M25 junction 10/A3 Wisley interchange

TR010030

9.78 Applicant's comments on Interested Parties responses to Examining Authority's second written questions

9.78 Applicant's Comments on Interested Parties responses to Examining Authority's second written questions

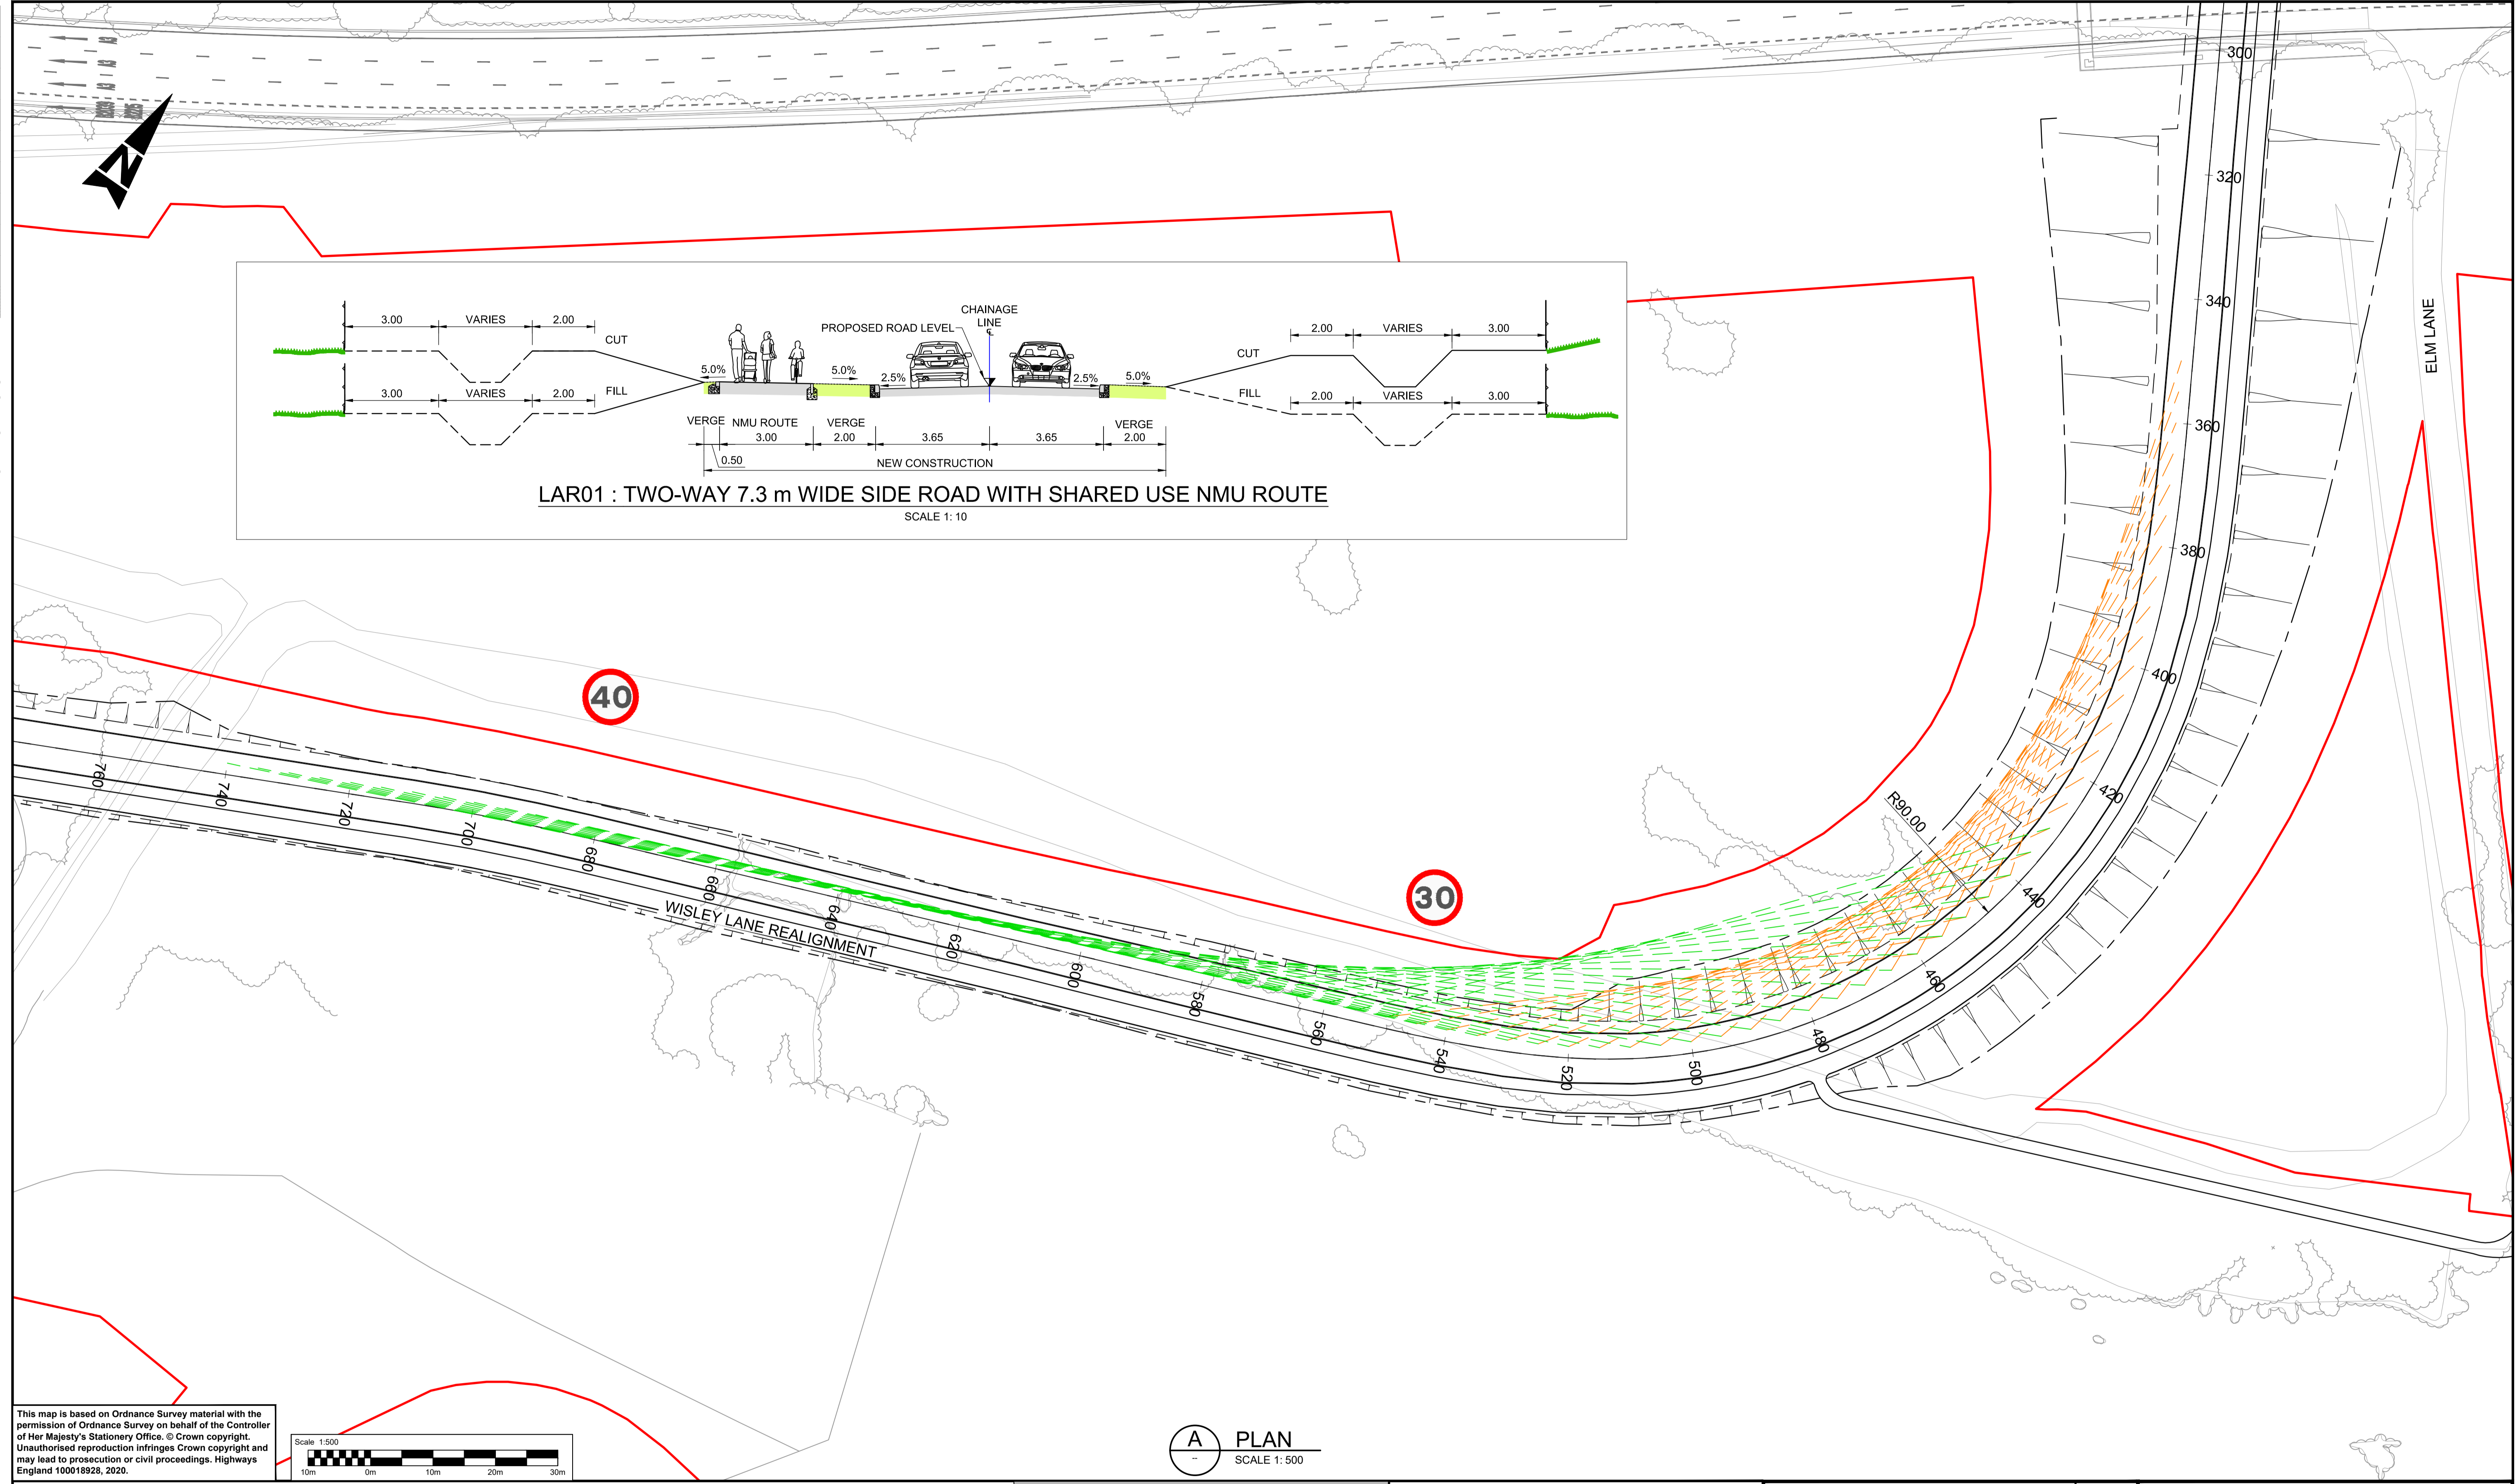
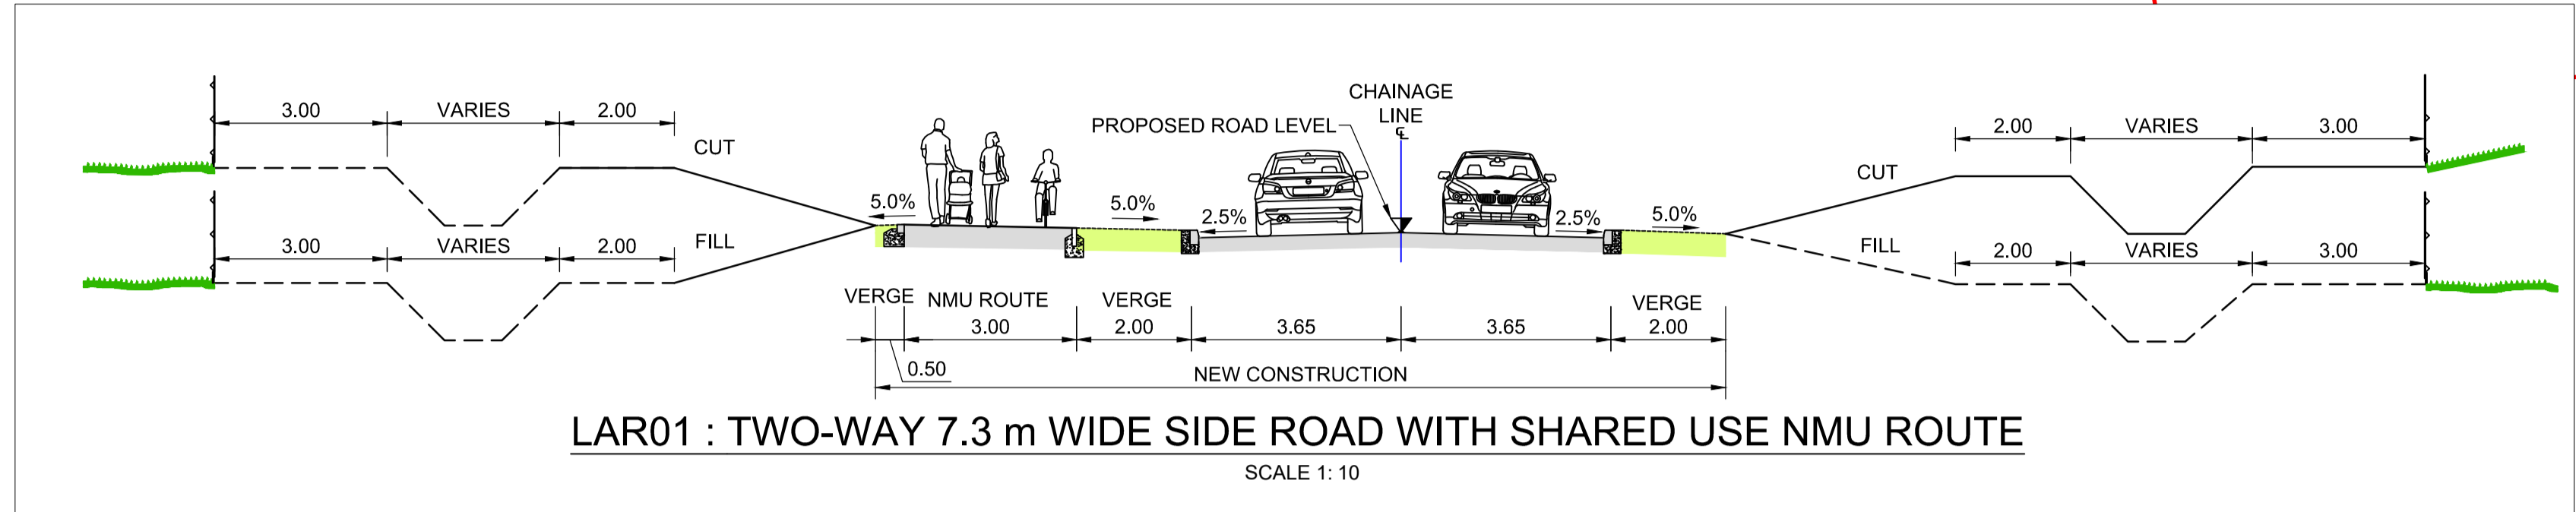
Question Number	Question to:	Interested Party Responding	Question	IP Response	Highways England Response
					<p>The scheme proposal has a reduced forward visibility splay on the Painshill interchange northbound off slip road and on the segregated left turn lane. This is due to obstructions to the visibility of an existing retaining wall on the northbound slip road, the existing Feltonfleet School boundary and a proposed retaining wall on the A245 westbound. Mitigation measures to be agreed with SCC could include additional road markings such as "SLOW" / edge markings, vehicle activated junction warning signs such as bend with distance plate, and high friction surfacing. Ongoing discussion taking place with SCC. Any resulting departures from standard will be prepared and discussed with SCC.</p> <p>With reference to the SCC letter submitted at Deadline 5 [REP5-028], within Item 3a, SCC state, with regard to the Wisley Lane diversion forward visibility issue:</p> <p><i>'The drawing submitted within REP4-006 did not correctly show the required forward visibility for the 30mph speed limit. HE advise that a revised drawing will be submitted at deadline 5.'</i></p> <p>A revised drawing showing the forward visibility for both the 30mph and 40mph speed limit has been issued to SCC and is attached in Appendix B as drawing number HE551522-ATK-HGN-XX-SK-CH-00034_C02.</p>
